Nevada Division of Environmental Protection-Bureau of Air Quality Planning (NDEP-BAQP) BART Determination Review of Nevada Energy's Fort Churchill Generating Station Units 1 and 2

FIGURE 1
LEAST COST ENVELOPE

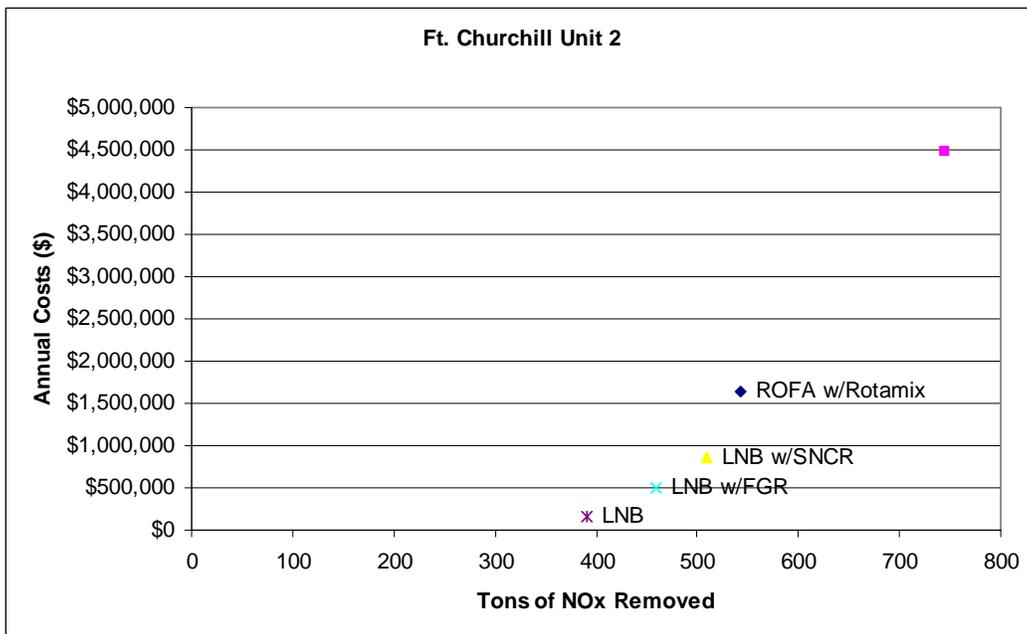
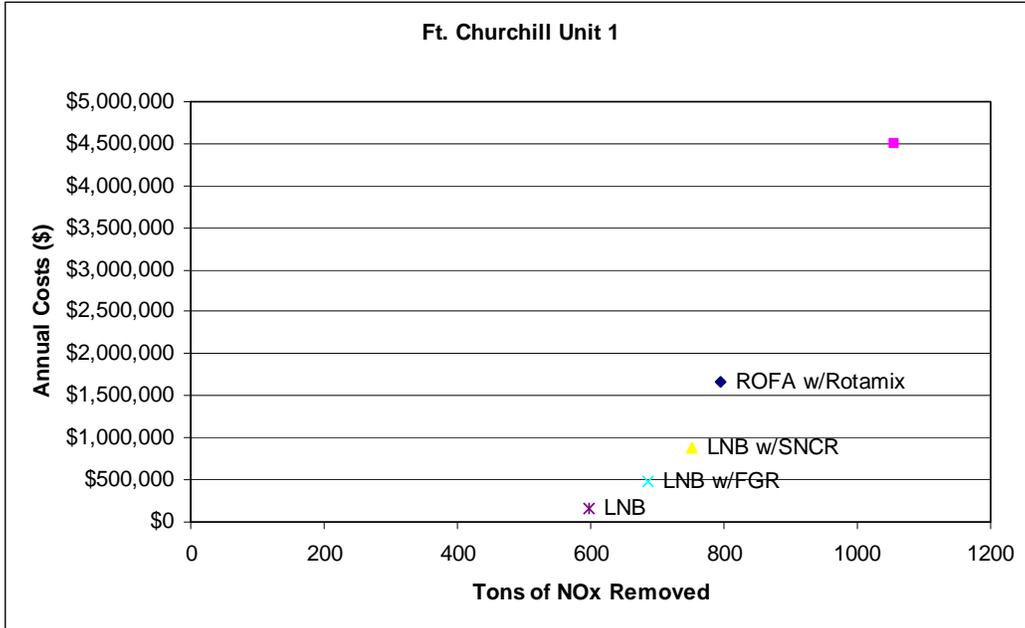
NDEP specifically reviewed the cost per ton of NO_x removed for each unit at Ft. Churchill and determined that installation of LNB with FGR meets the BART criteria, with associated costs of \$716 to \$1,070/ton of NO_x removed for Units 1 and 2, respectively. These values are considered cost effective. The cost data from the tables above are presented graphically in Figure 1. NDEP also concluded based on a review of the economic analysis that the \$/ton of NO_x removed increased significantly for LNB with SNCR, ROFA and SCR technologies without any clear environmental benefit.

Visibility improvement upon installation of LNB with FGR is anticipated to be greater than modeling with NVE's proposed BART limit presented in their October 2008 Report. Modeling the visibility impact based upon the emission rates presented in Table 1 will be performed at a

later date. Thereafter, data will be added to this report. Based on this review, NDEP concludes that for NO_x the installation of LNB with FGR with an emission level at 0.20 lb/MMBtu for Unit 1 and 0.16 lb/MMBtu for Unit 2, on a 12-month rolling average, is BART.
